Florida Department of Transportation

ROADWAY DESIGN BULLETIN 11-03

DCE MEMORANDUM 02-11

SUBJECT: OSHA RULE (29 CFR Part 1926) CRANES AND DERRICKS IN CONSTRUCTION

Example 1

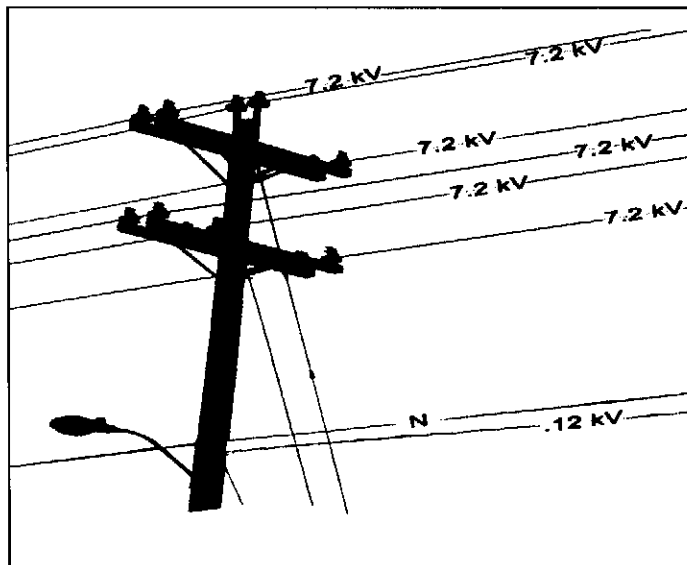
For all projects with a letting date after July 1, 2011, all overhead electrical facilities shall be labeled with the line voltage. Utility owners will be required to furnish the line voltages at the coordination phase. Multiple lines with different voltages may be found on a common pole line. For labeling purposes only one line should be shown even if there are multiple lines with different voltages. For poles with multiple lines and multiple voltages which do not exceed the 50kV threshold (see Example 1), the line should be shown in the plans as -----OE (< 50kV)-----.

Example 2

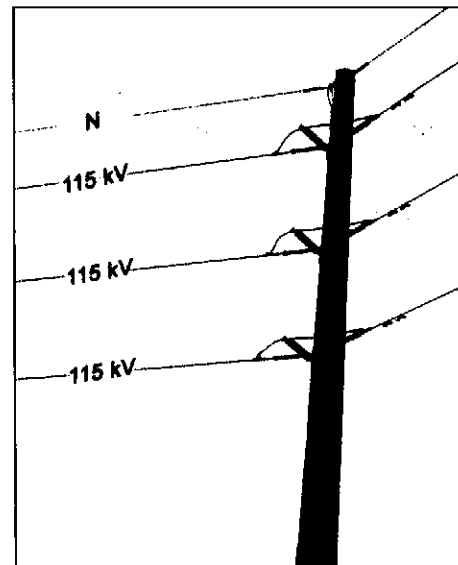
For poles with multiple lines and multiple voltages which exceed the 50kV threshold (see Example 2), the line with the greatest vertical clearance will be labeled first, separated by a slash mark, and followed by the next voltage as you move down the pole. If multiple voltages exist at

the same height, the highest voltage should be labeled. In Example 2, the line should be shown in the plans as -----OE (115kV/115kV/115kV)----- or -----OE (All lines 115kV)-----.
